CITY COUNCIL AGENDA ITEM COVER MEMO

Resolution authorizing the Mayor to enter into an agreement between the City of Huntsville and the low bidder, SJ&L General Contractor, L.L.C., for Jefferson Street Streetscape Improvements, Phase I, Project No. 65-15-SP04

Document Name: SJ&L-Jefferson Street Streetscape, Phase I, Project No. 65-15-SP04

Sheet C7

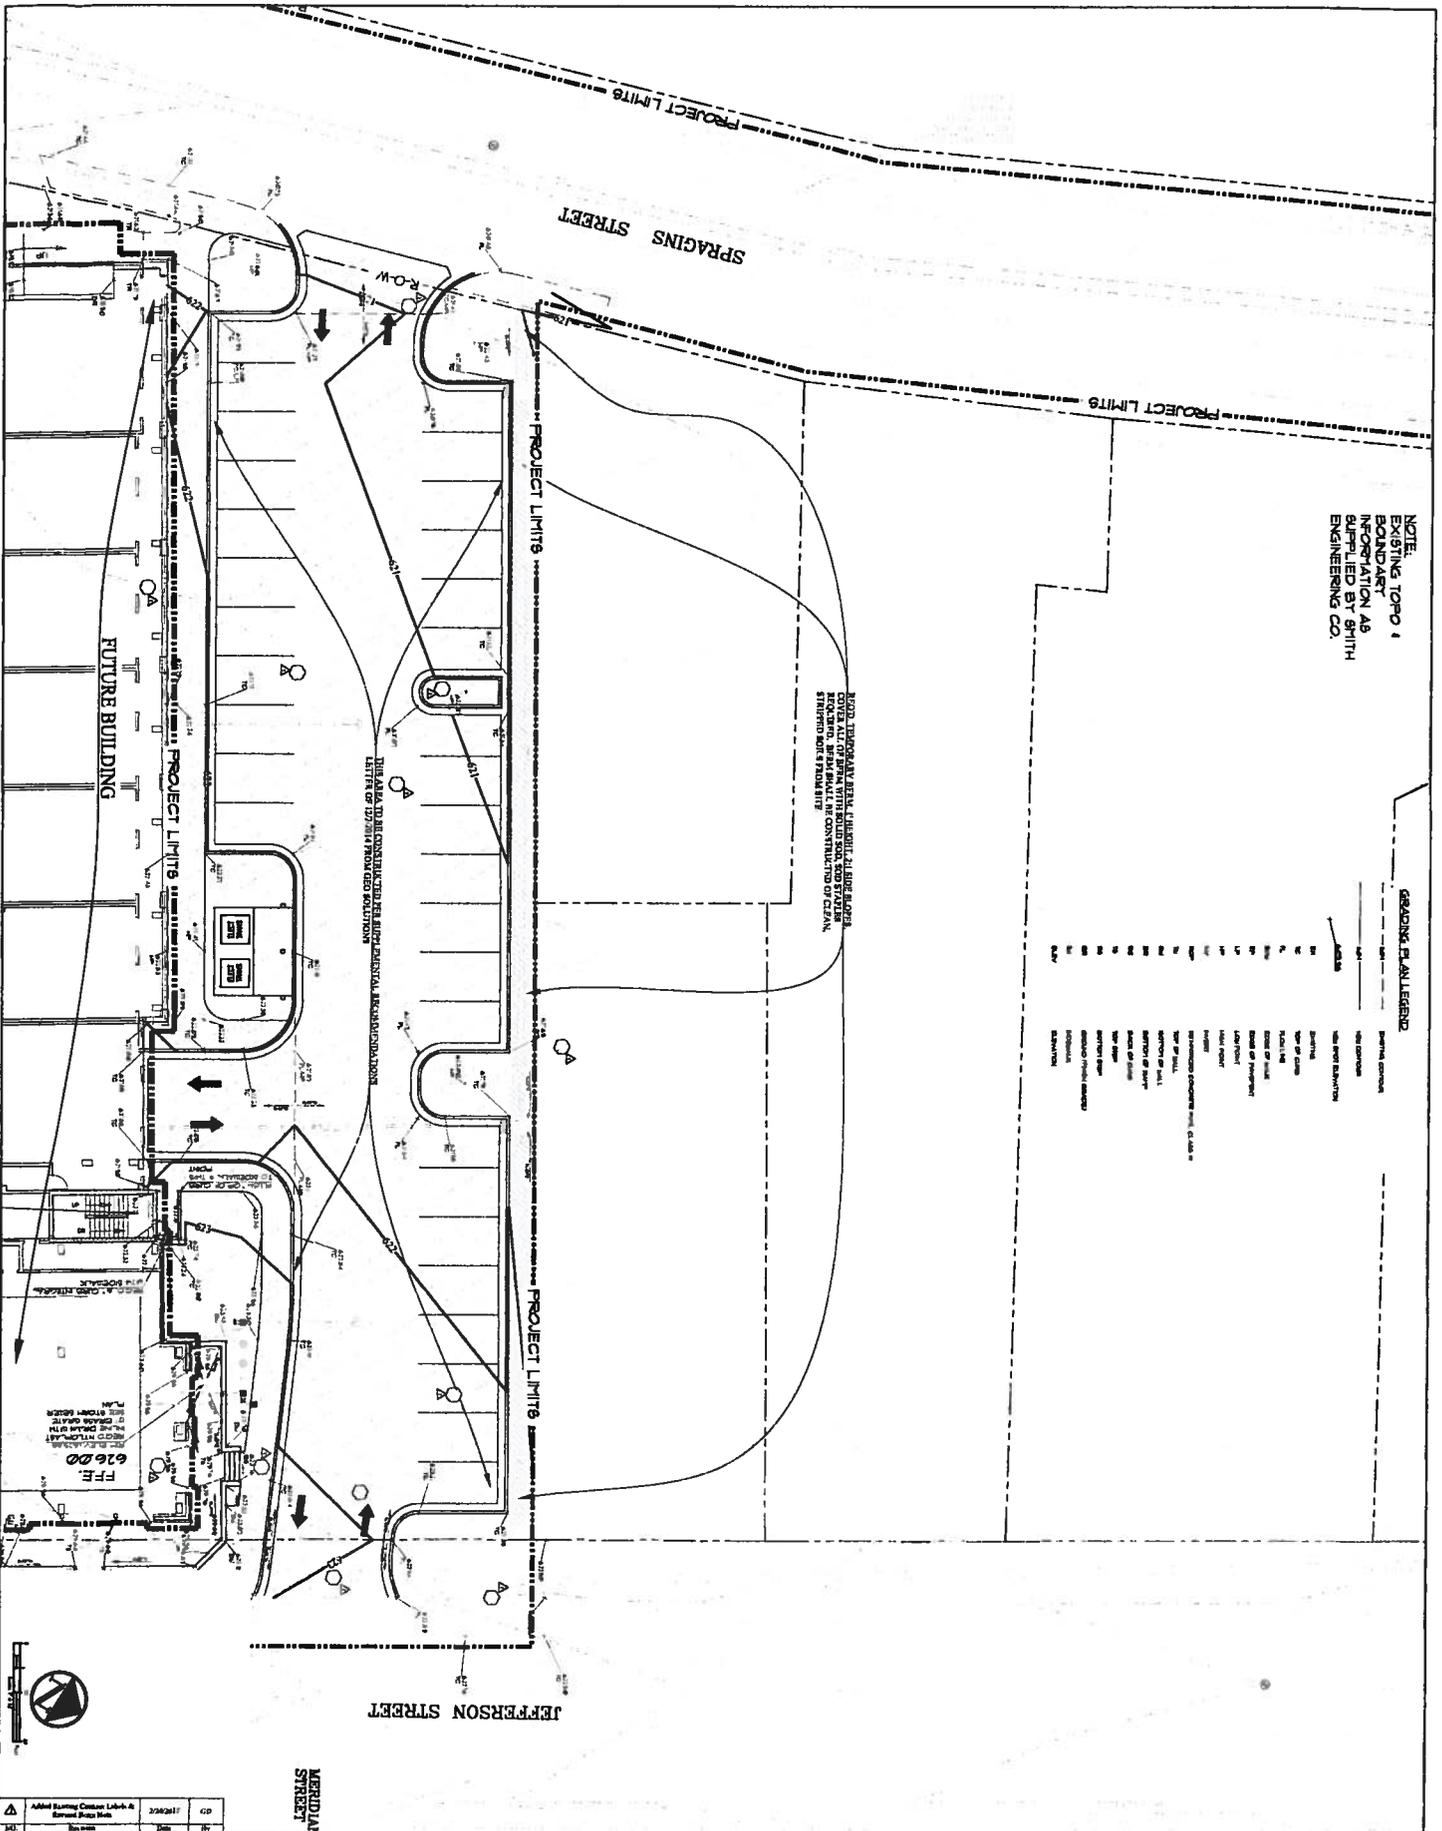
2.2 Sheet C7, The Avenue Phase 1 – Grading Plan  
Re-issue plan, per sheet C-7, attached hereto and posted on COH website.
